**NOTICE OF DECISION TO CONSENT TO CHANGE TO PROPOSAL DURING
ASSESSMENT**

Tonkin Highway Grade Separated Interchanges (Hale Road and Welshpool Road)
Assessment No. 2293

STATEMENT OF REASONS

Proposal: Tonkin Highway Grade Separated Interchanges (Hale Road and Welshpool Road)

Figure 1 – Changes to Development Envelope

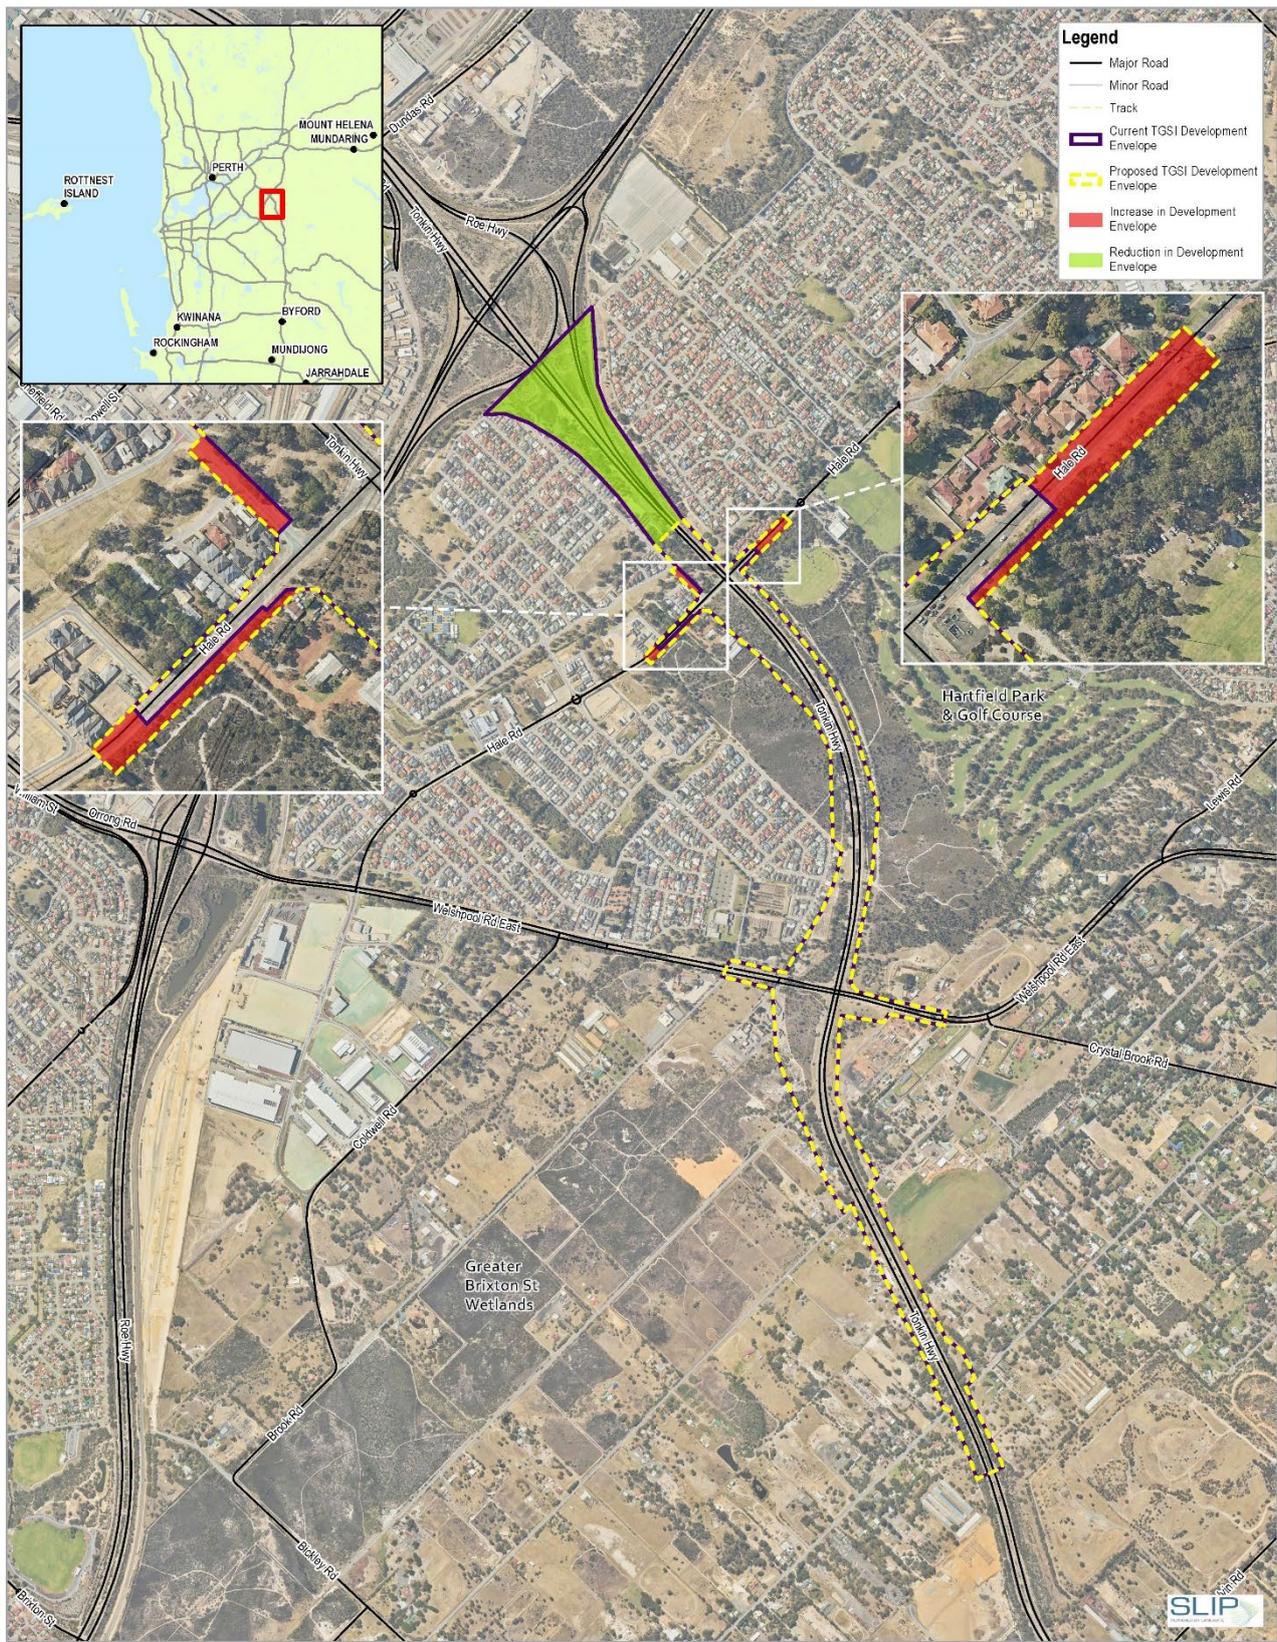
The changes are the result of the removal of a 14.62 ha portion of the northern extent of the development envelope as this area is covered by a native vegetation clearing permit (CPS 524/25). Three additional areas totalling 1.18 ha have been added to the development envelope to accommodate a redesigned intersection at Hale Road and Tonkin Highway. This redesign has also required the relocation of Western Power services from above ground to below ground (Figure 1).

The northern extent of the original Development Envelope was reduced by 14.62 ha from Roe Highway south to approximately 240 m north of Hale Road. This is as a result of overlapping and active Commonwealth (EPBC 2010/5384) approval, and State native vegetation clearing permit (CPS 5242/5) associated with Perth Airport and Freight Access Project (Gateway WA).

Three areas totalling 1.18 ha have been added to the development envelope. Within these areas:

Proposal element	Location	Referred extent	Proposed extent
<i>Physical element</i>			
Clearing and disturbance for road construction and associated infrastructure	Figure 1	The Development Envelope comprises a total area of 65 ha. The proposal will result in the clearing of 24.1 ha of native vegetation	The Proposal comprises a total area of approximately 51.5 ha, including clearing or disturbance of up to 20.42 ha of native vegetation and 1.80 ha of non-native vegetation/revegetation suitable for fauna habitat
